**Strahan Place Subdivision #2**  
PART OF NW QUARTER OF SECTION 13,  
TOWNSHIP 6 NORTH, RANGE 3 WEST, S.L.B.&M.  
WEBER COUNTY, UTAH  
2 Aug, 2015

**PRELIMINARY #2**

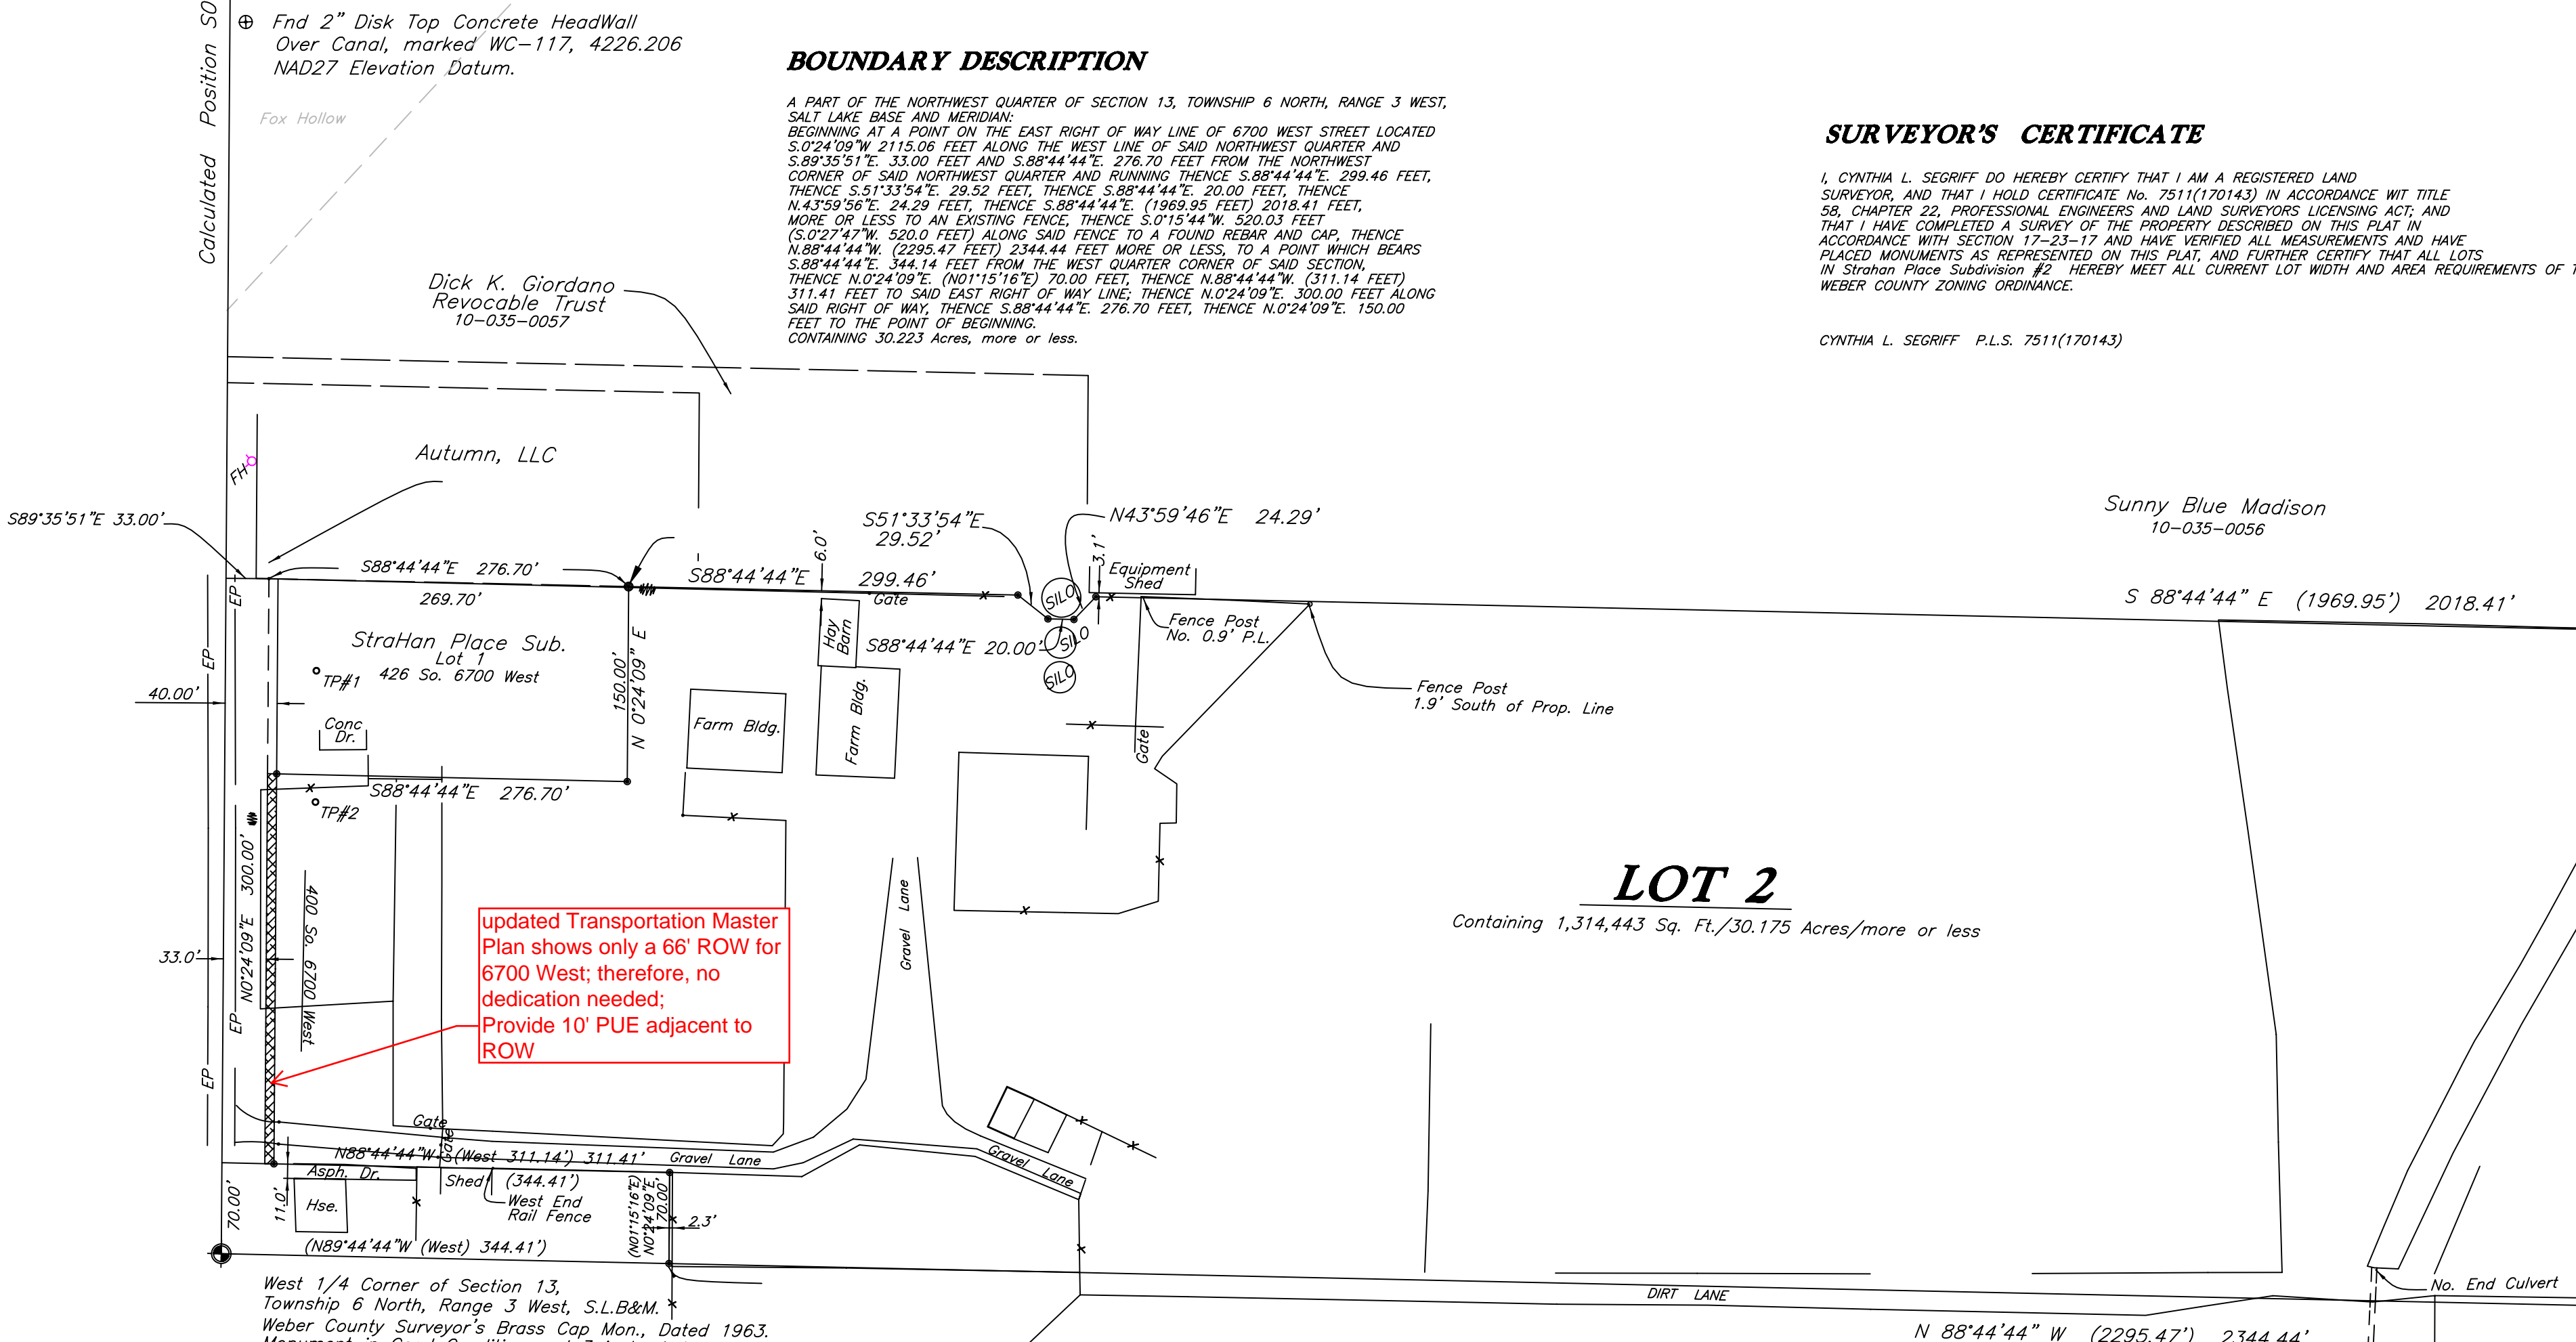
updated Transportation Master Plan shows only a 66' ROW for 6700 West; therefore, no dedication needed; Provide 10' PUE adjacent to ROW

spelling error

Webster County maintains this drainage; please provide drainage easement, including 10' offset from top of bank, each side.

Recommend changing color so it shows up during plotting hard copy
